TITLE
2025 KSDP - JACKSON
74" HOME THEATER

DWG. NO.
CF7000649
DR. J. ANCHETA

REV. **E**
DATE **05.18.23**

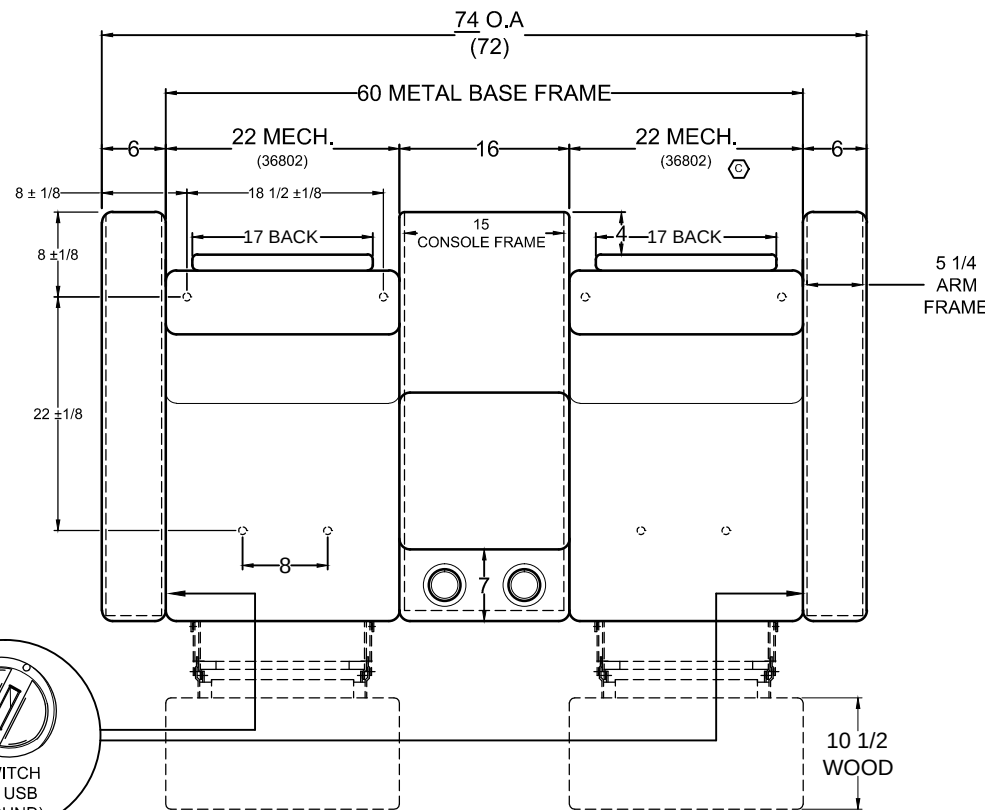
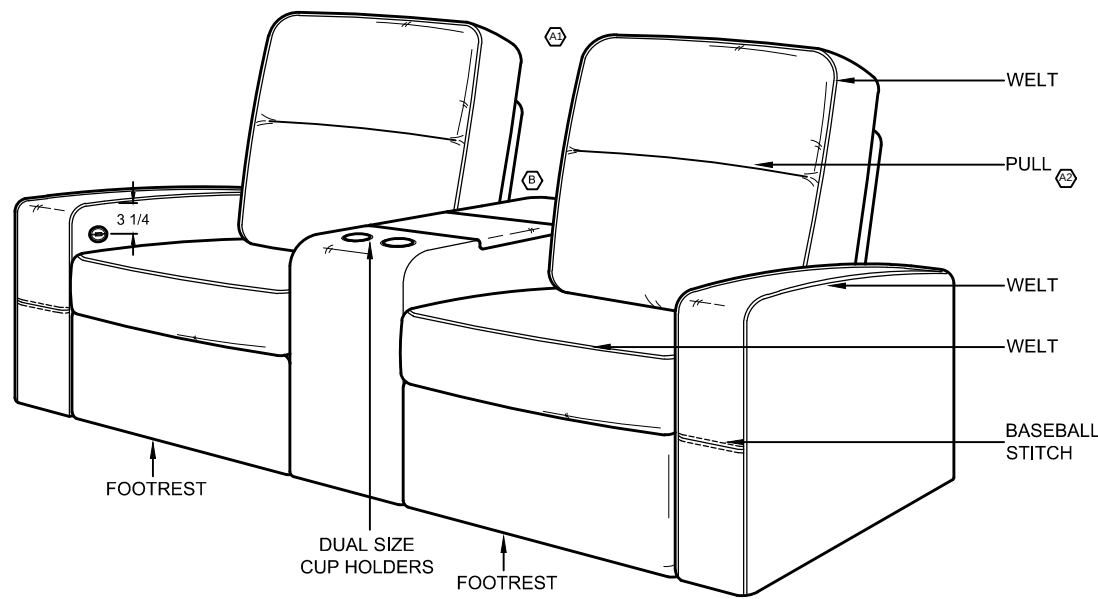
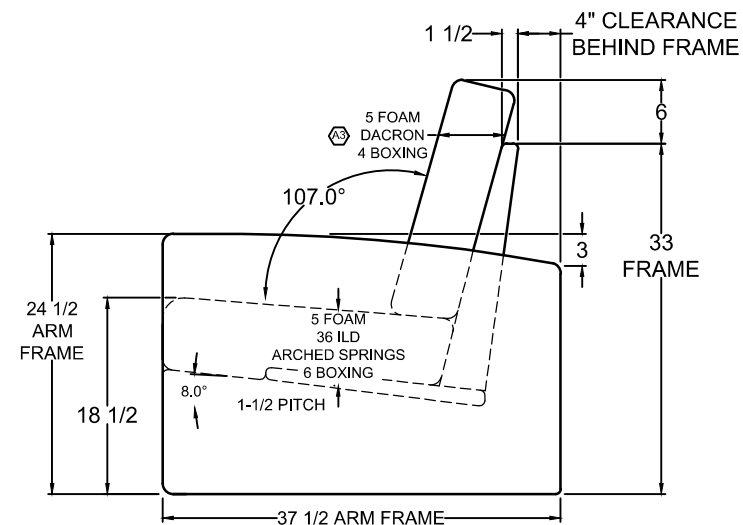
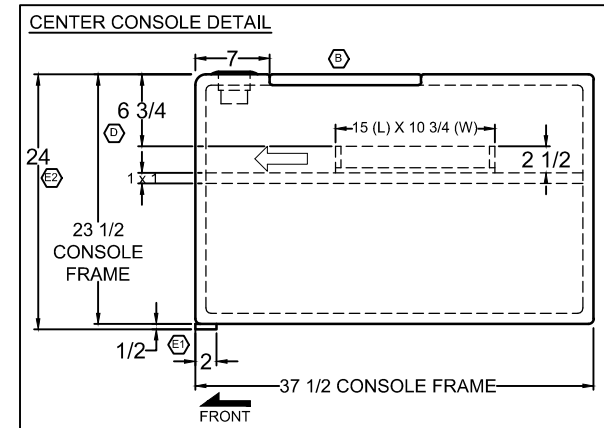
JA	E	PER RL, [1] ADD 1/2" x 2" WOOD TO BOTTOM OF CONSOLE. [2] ADD 24" HEIGHT DIM TO CONSOLE.	09.23.24
JA	D	PER RL, CORRECT CONSOLE SHELF HEIGHT TO 6-3/4"; WAS 4-3/4".	02.21.24
JA	C	PER RL, ADD '36802' NOTE TO 22" POWER MECH DIM.	08.09.23
JA	B	CHANGE TO FLUSH LID STORAGE. (REF. ECO # 029-2023)	06.21.23
JA	A	PER RL, [1] MAKE BACK PILLOWS TALLER, [2] ADD PULL TO BACK PILLOWS, [3] CHANGE BACK PILLOW FOAM DETAILS TO 5 FOAM; WAS 3 FOAM. ALSO REMOVED 18 ILD DW.	06.14.23
